ADDENDUM NO. 2

Rochester City School District

Dr. Walter Cooper, School #10

February 28th, 2018

1 LAYOUT PLAN
 Scale: 1" = 30'

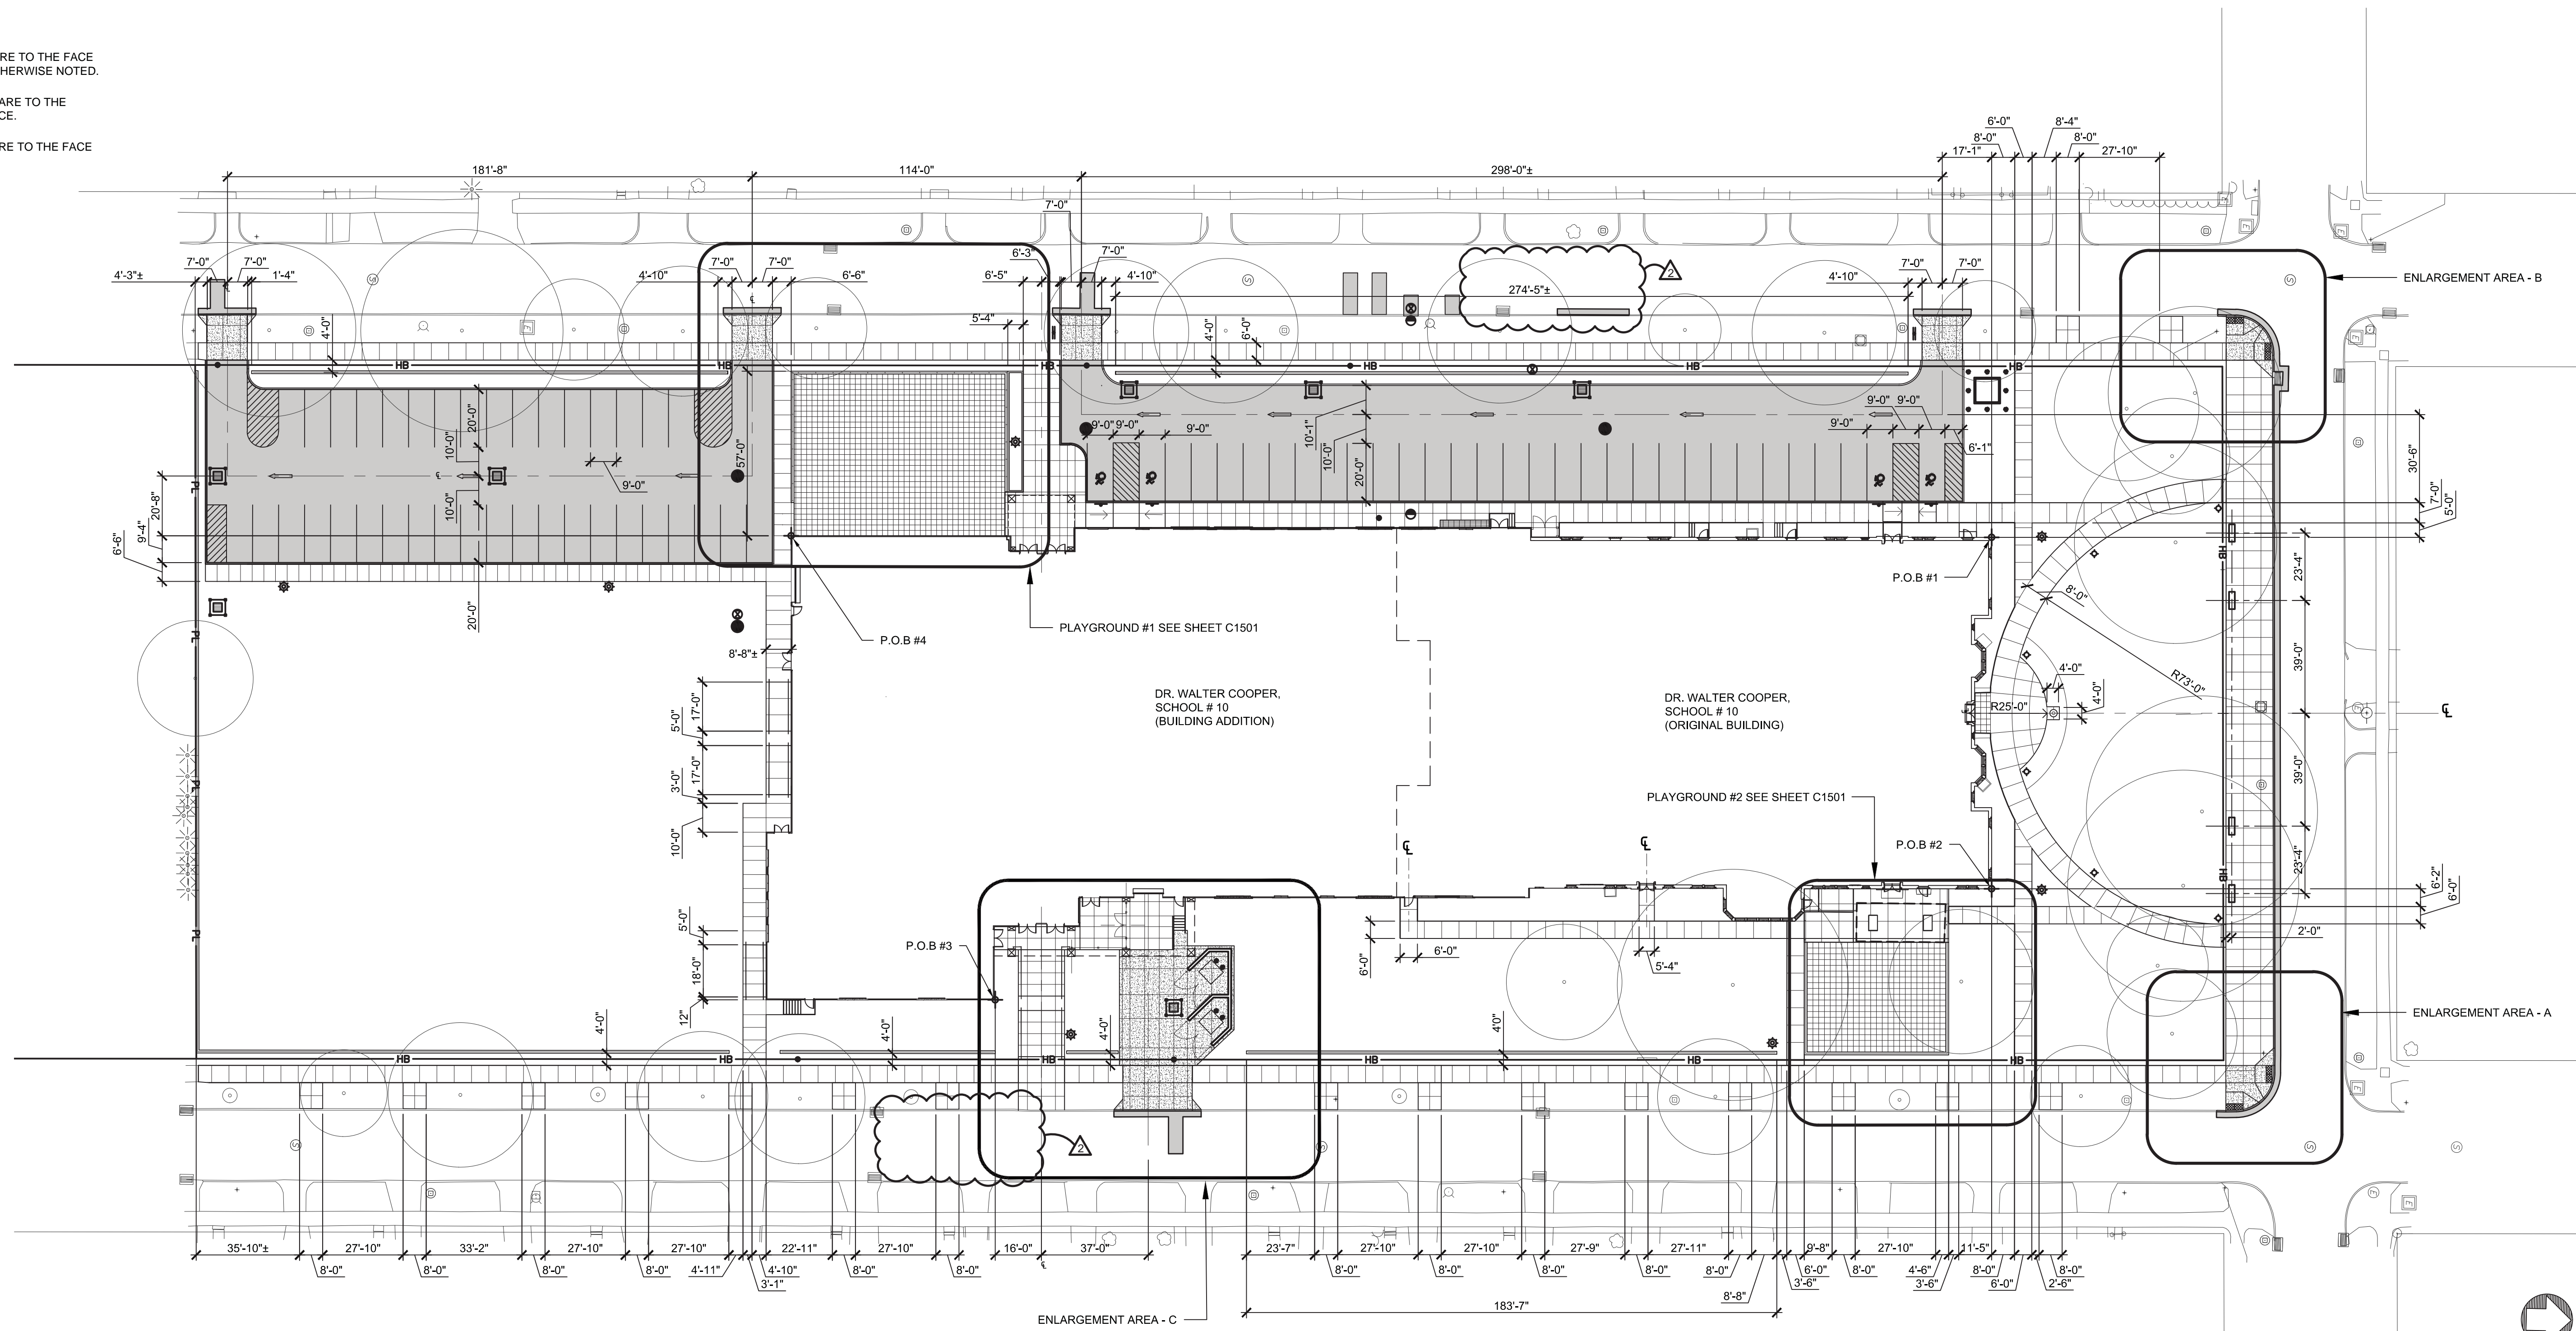
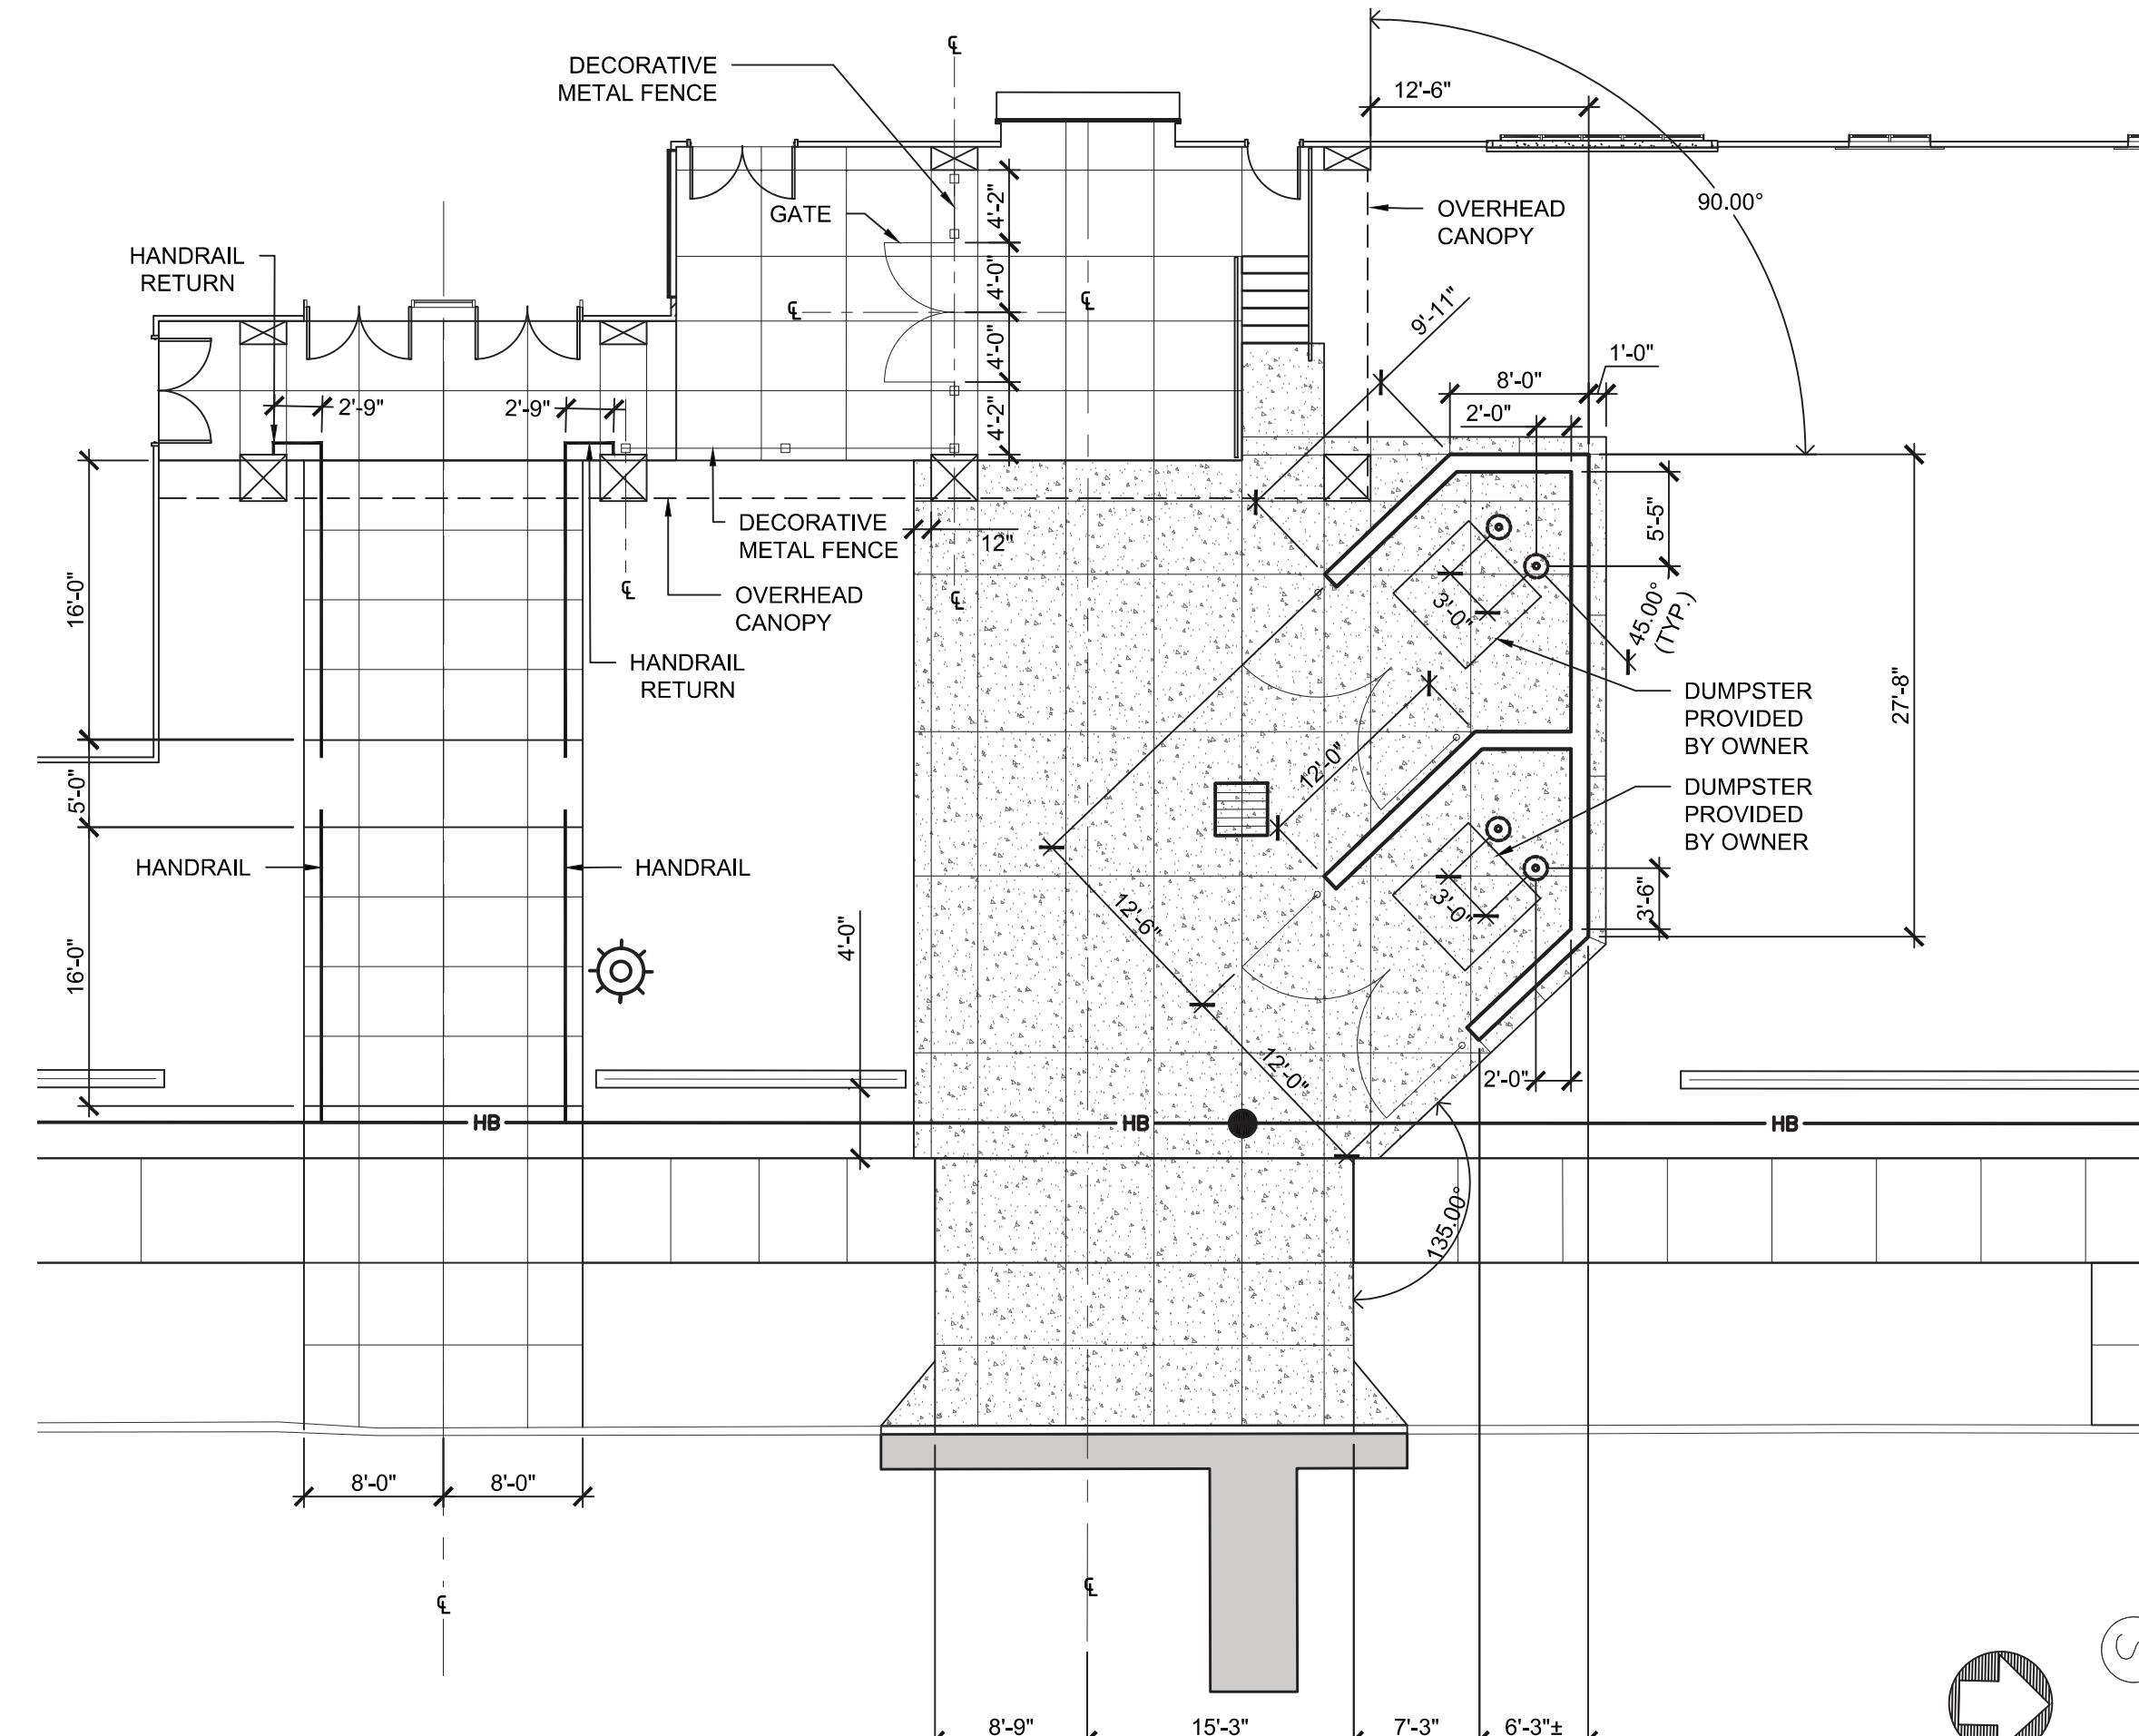
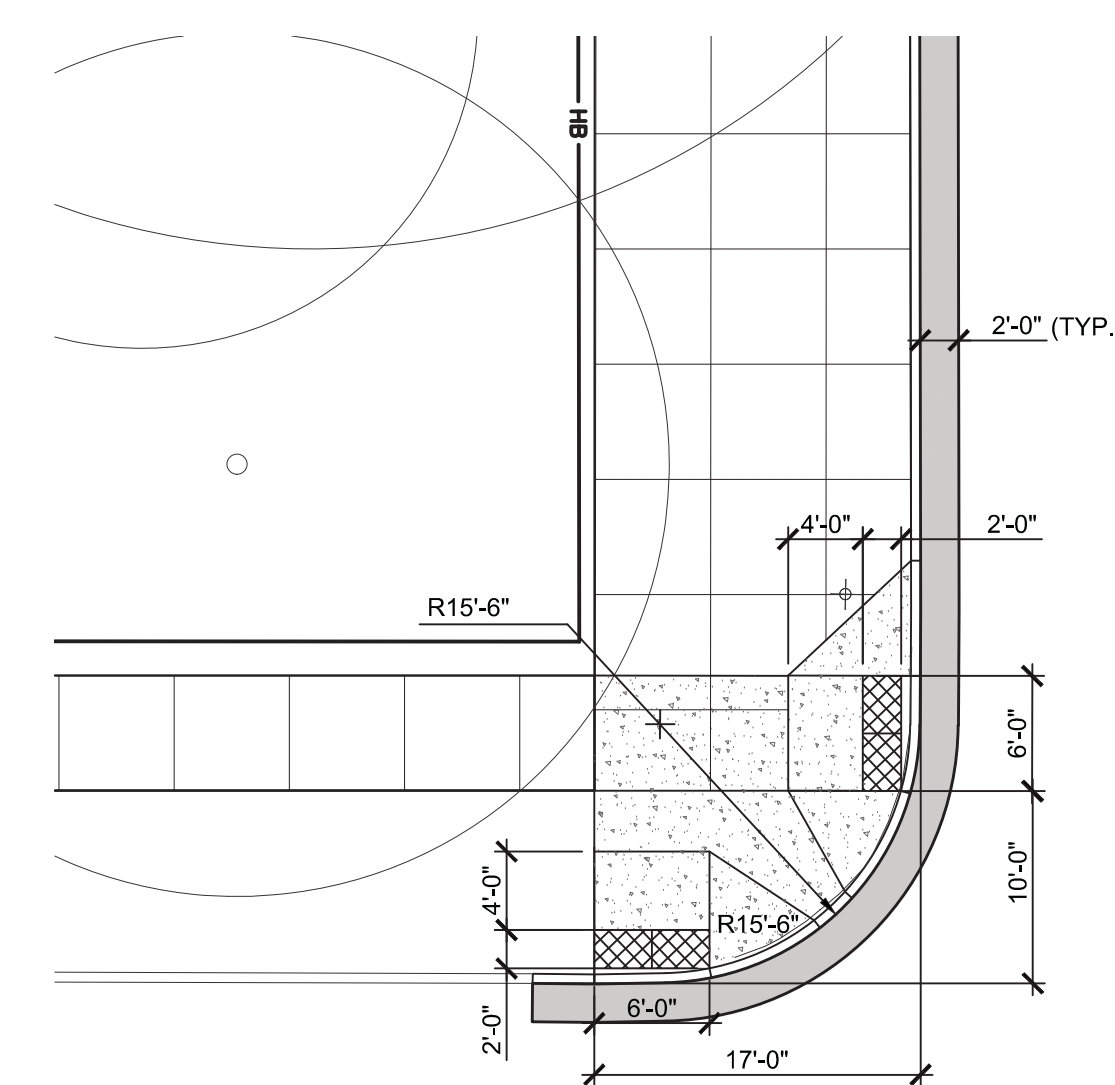
Item AD2-13 **REPLACE** drawing in its entirety with attached “C1102 – SITE LAYOUT PLAN.” Remove pavement and curb restoration where existing utilities will be abandoned in the ROW.
